Re: Canon TI – 4041 Jefferson Plaza NE Albuquerque, New Mexico

RE: pond modification at 4041 Jefferson PLaza Suite 200

Jefferson Plaza Office Building, 4041 Jefferson Plaza NE,

Re: Jefferson Plaza Office Building Grading and Drainage Plan Engineer's Stamp dated 6-14-07 (E17/D16E1)

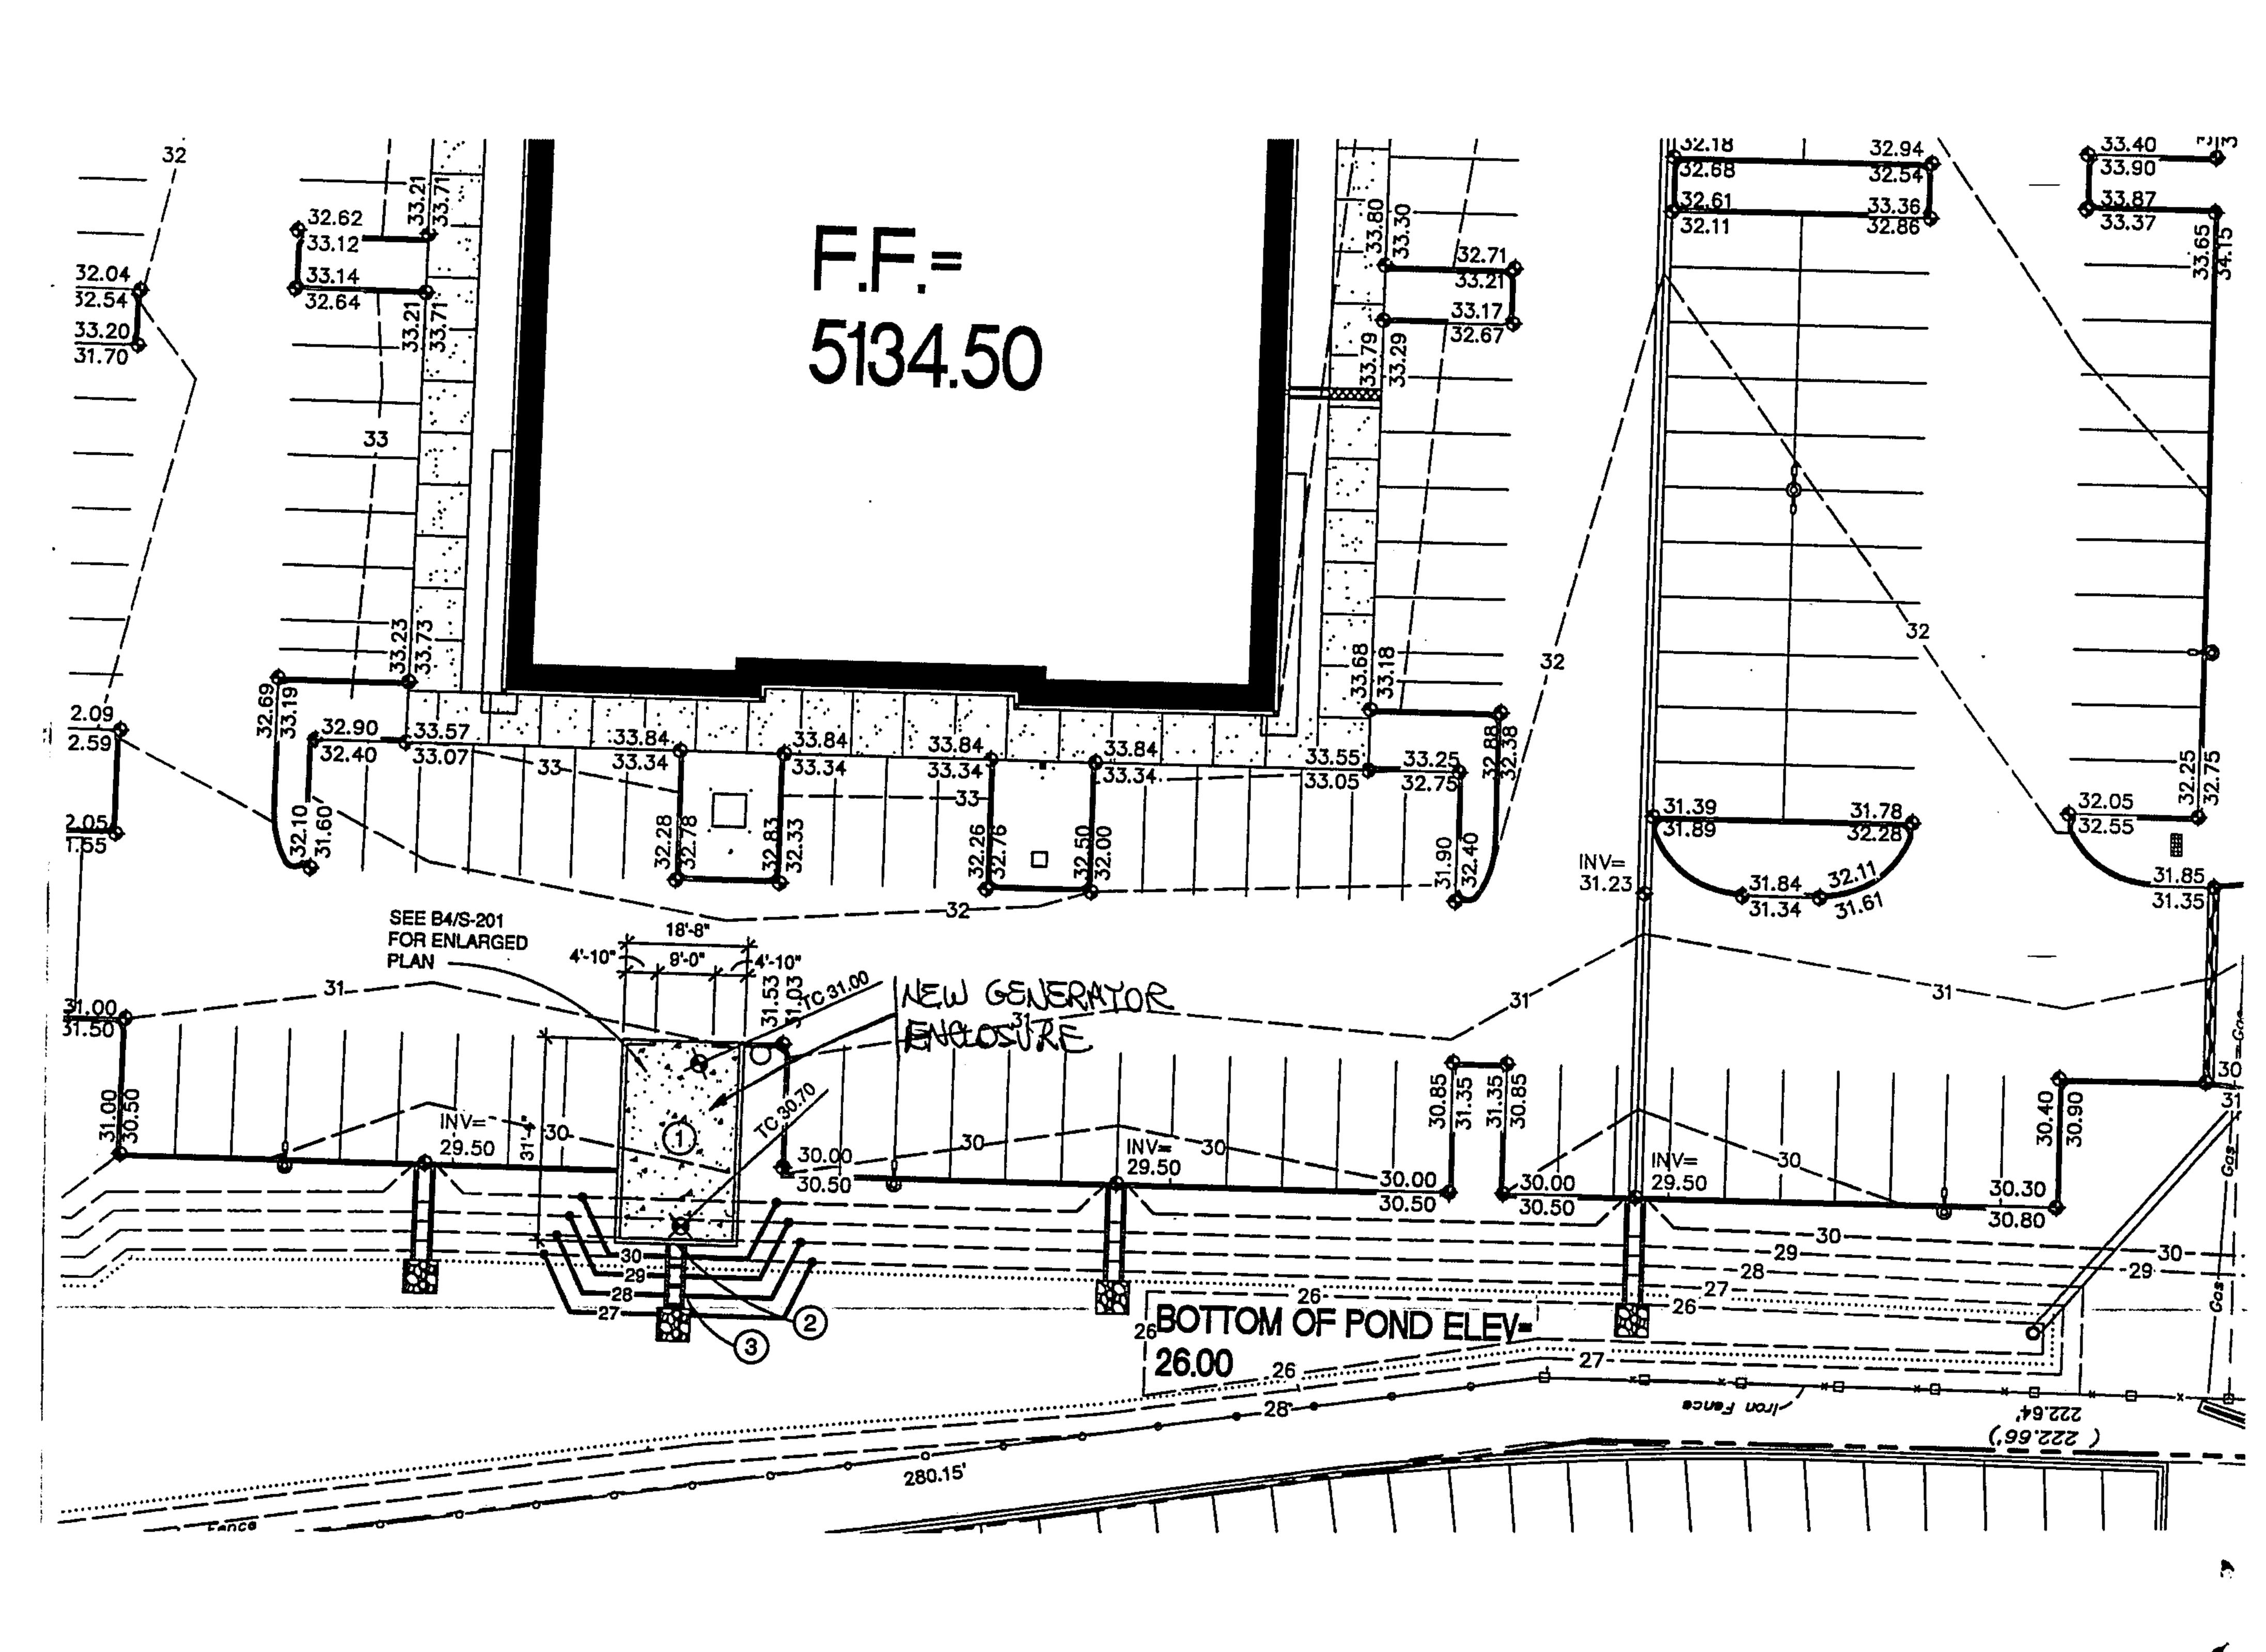
The scope of this project includes the construction of a new Generator enclosure at the west end of the existing parking lot of this property. The generator pad will require installation of some fill to build up the pad and this earthwork will extend into the drainage pond on the west side of the site. The enclosed drawing is a portion of the site plan indicating the extent of the work required for this pad installation. The volume of dirt required to build up the pad that extends into the pond is approximately 792 CF. This volume will reduce the water storage capacity of the west pond by 2.7% of it's original capacity. The site has 2 ponds and this earthwork will reduce the entire pond storage on the site by approximately 1.1% of the original 70,762 CF of water storage capacity. In a maximum storm event this reduced volume represents a water level increase of 0.03 feet, or 3/8 inch. Therefore, the relative impact on the pond capacity on the site is minimal and the earthwork will have no significant effect on the drainage runoff storage capacity on site.

I'm looking at a building permit for 4041 Jefferson Plaza Ste 200, which shows a modification to the pond certified by Fred Arfman.

Submit a copy of the plan to Hydrology for review and approval, including the new pond volume and water surface elevation and a statement that this will not adversely affect the function of the pond or something like that.

Hydrology has reviewed the attached letter and it is satisfactory for Building Permit approval.
